NOAA WIND PROFILER MODIFICATION NOTE 4

SUBJECT : Wind Profiler Air Conditioner Relay Heat Sink

Installation

NOAA WIND PROFILER MODIFICATION NOTE 5

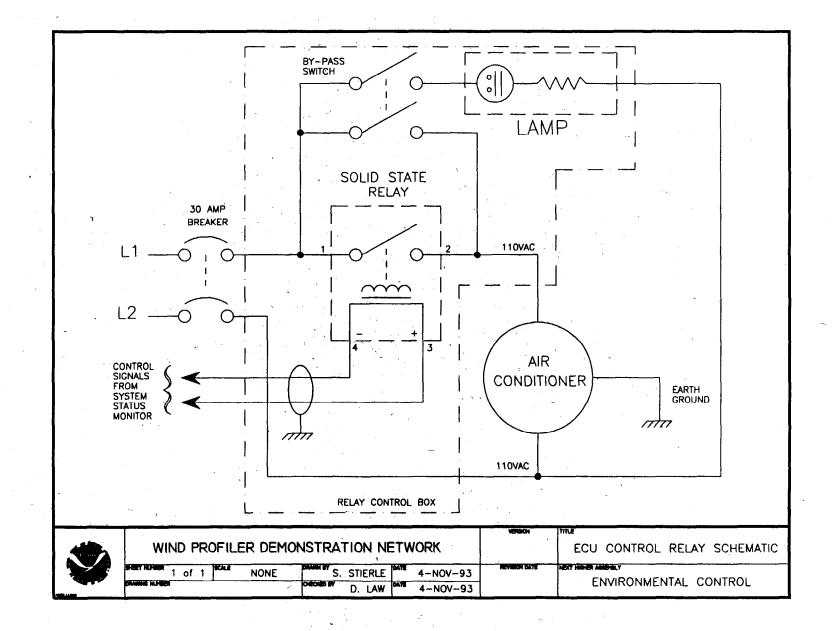
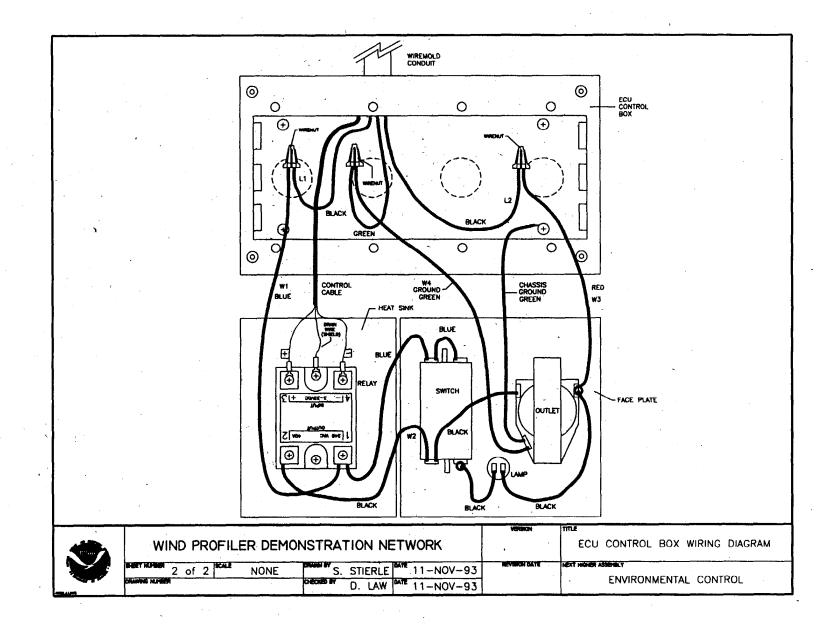
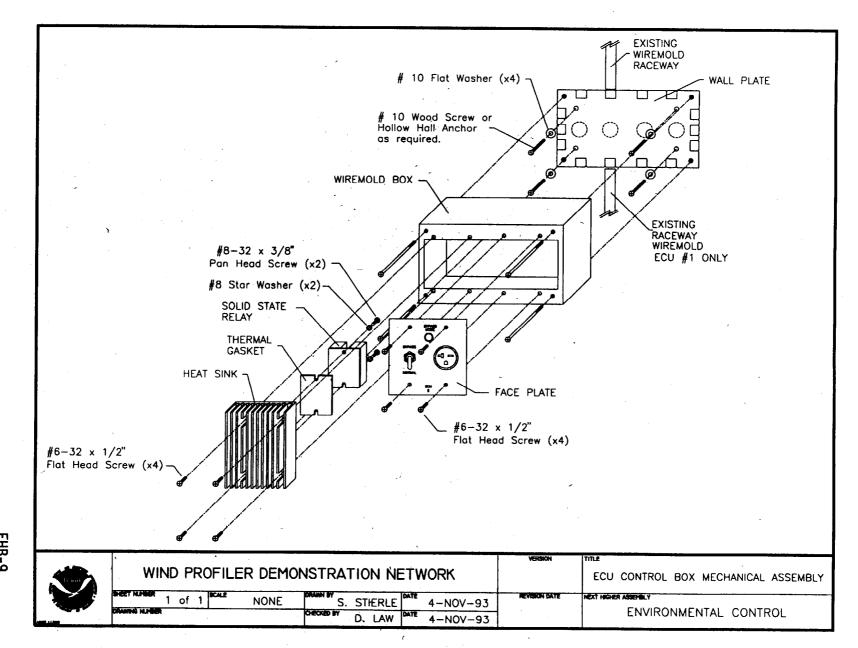
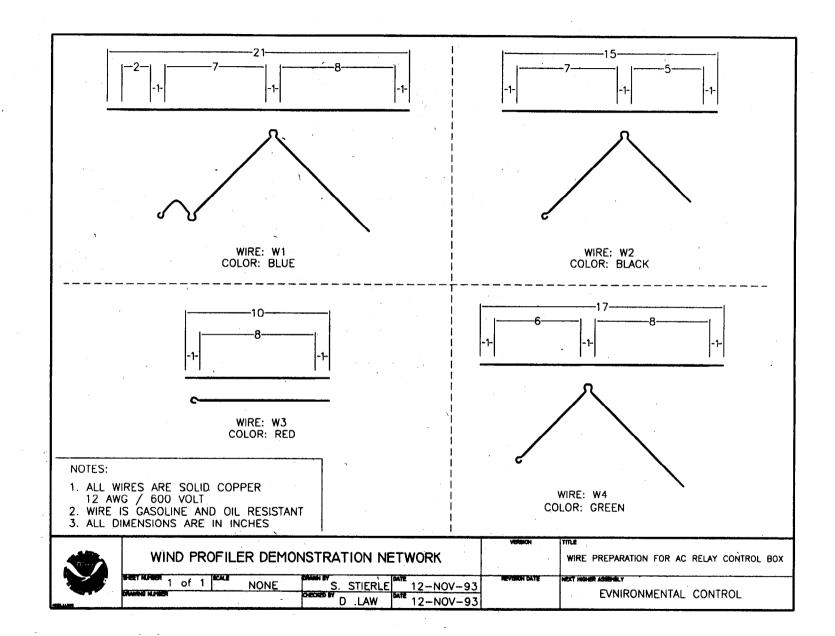
There have been numerous dramatic failures of the revised air conditioner relay heat sink kits provided by Unisys due to overheating of the solid-state relay.

The PPO has designed a new relay/heatsink configuration for all profiler sites. This new modification provides sufficient heat transfer from the solid-state relay to the ambient shelter air to prevent relay overheating. Furthermore, it provides more room for wiring inside the mounting box as well as simplifies repairs. The Profiler LRU Replacement Guide or Operations and Maintenance Manual should be used as a maintenance guide by the technician.

- 6. Disconnect wires as required to completely remove the face plate from the box leaving the bypass switch, indicator lamp, and 220-volt receptacle attached to the face plate. Completely remove the box and wall plate from the shelter wall.
- 7. Mount the wall plate for the new box as shown in the drawing titled "MOUNTING PLATE FOR ECU CONTROL BOX." Center either of the two inside tabs of the wall plate to the metal raceway.
- 8. Mark the position of the mounting holes on the wall and drill a 1/8" pilot hole: If wood is used to mount the wall plate, use the wood screws with #10 flat washers provided. Otherwise, drill a 1/4" hole to use the hollow wall anchors with #10 washers provided.
- 9. Lay the new heat sink and face plate assemblies face down and wire them together using the pre-cut and formed wires as shown in the drawing titled "ECU CONTROL BOX WIRING DIAGRAM" (sheet 1 of 2).

- 13. Connect the blue and red wires to the two black AC lines that lead into the raceway (using two yellow wire nuts). There is no preferred polarity for the AC wires. Refer to the drawing titled "ECU CONTROL BOX WIRING DIAGRAM" (sheet 2 of 2) for an illustration of these wiring connections.

- 14. Connect the relay control lines as shown in the drawing titled "ECU CONTROL BOX WIRING DIAGRAM" (sheet 2 of 2). Note that terminals 3 and 4 of the solid state relay are polarized. Match the polarity (labeled + and -) of the control wires to the polarity of the relay terminals.

- 15. Assemble the face plate and heat sink to the box as shown-in the drawing titled "ECU CONTROL BOX MECHANICAL ASSEMBLY" with the #6-32 screws.
- 16. Plug the air conditioner power cord into the outlet, set the switch in the NORMAL position, and toggle the air conditioner breaker to the on position.

Figure 1 Status Monitor Internal Component Layout

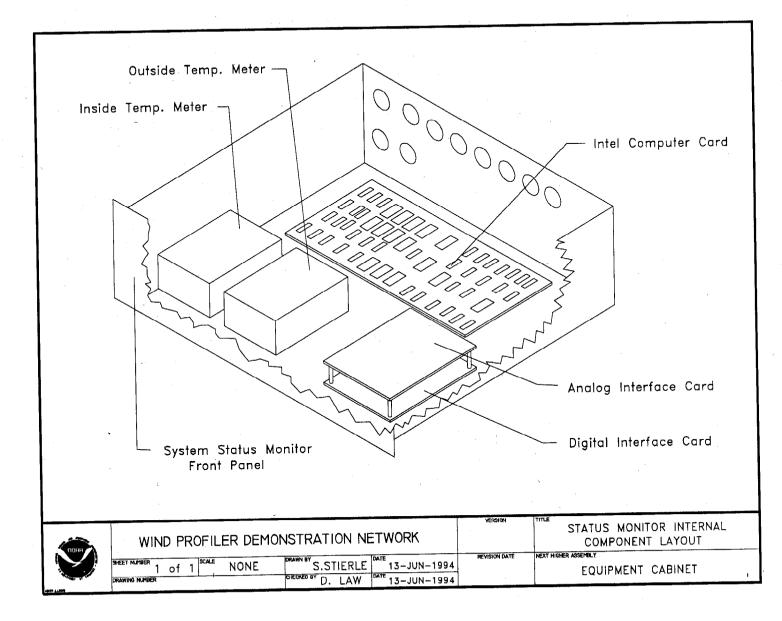
- 3. Carefully pull the status monitor out to its full stop position.
- 4. Remove the top cover from the **status monitor and locate the digital** interface circuit board in the chassis. Refer to Figure 1 for the internal component layout of the status monitor.

nana	WIND PROFILER DEM	ONSTRATION NETWORK	TYPE 2	DIGITAL INTERFACE SCHEMATIC POWER AMPLIFIER MODULE QUAD CONTROL DRIVER CIRCUITRY
	SHEET NUMBER 2 of 4 SCALE NONE DRAWING NUMBER	CHECKED BY D. LAW DATE 9-OCT-93	8-OCT-93	SYSTEM STATUS MONITOR

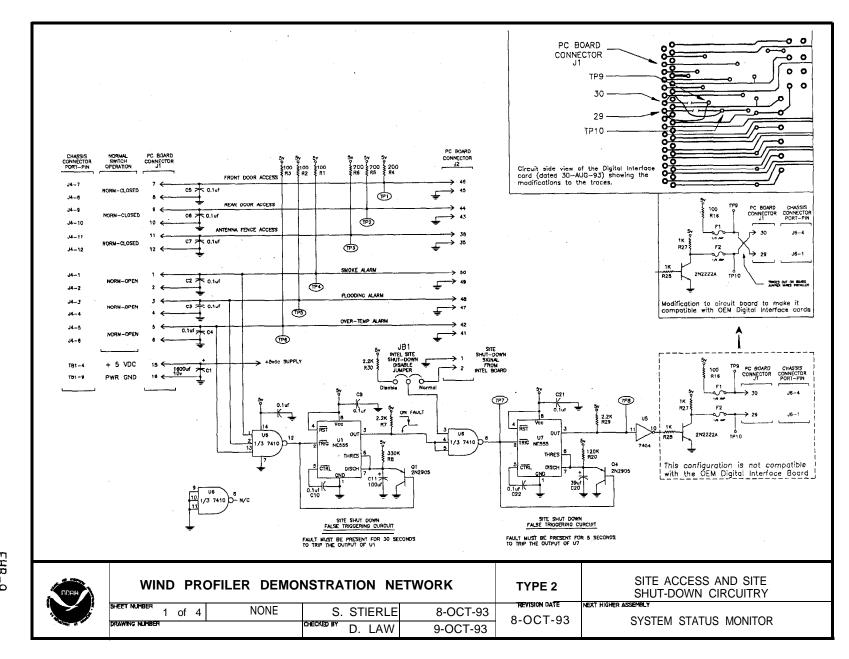
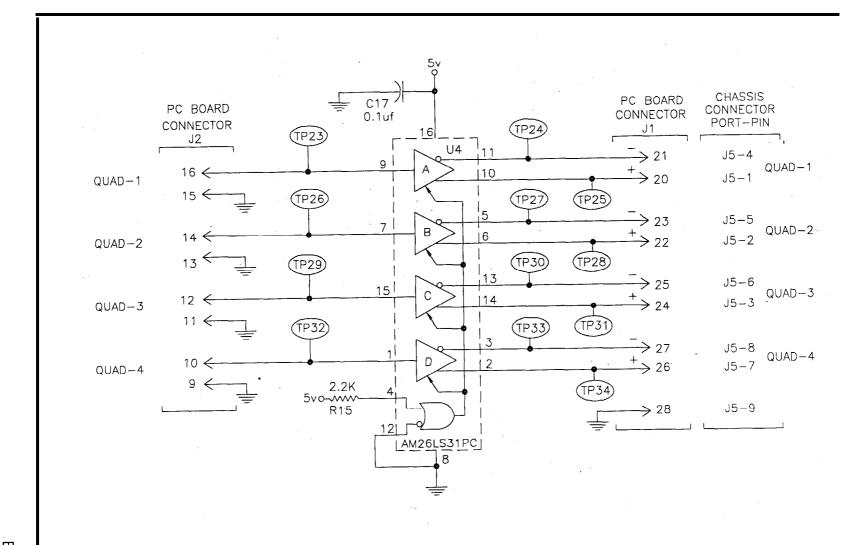
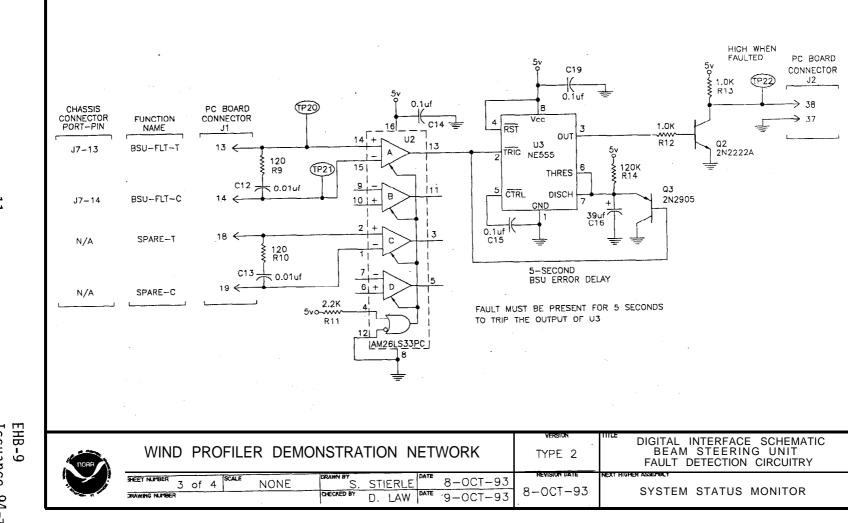
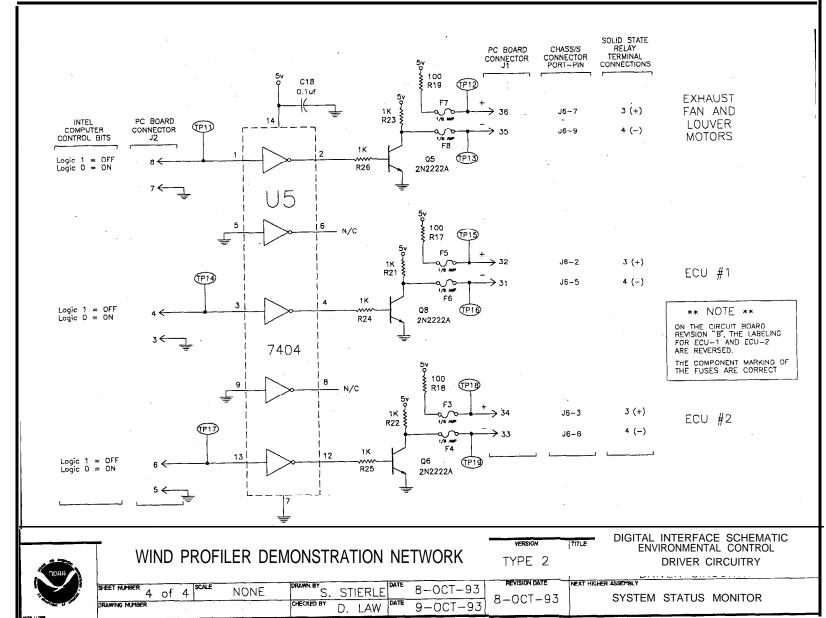
The Status Monitor Digital Interface Board has been redesigned to solve two problems:

- 1. The voltage levels supplied by the present Digital Interface Board are not high enough to drive the 40-amp solid state relays.
- 2. When the 40-amp solid state relay overheats, the excess current damages the Digital Interface Board. This problem is solved by fusing the output of the new Digital Interface Board.

- 14. If any of the tests fail, contact the Profiler Control Center for assistance at (303) 497-6033. Schematic diagrams of the digital interface board are supplied to aid in troubleshooting any problems.
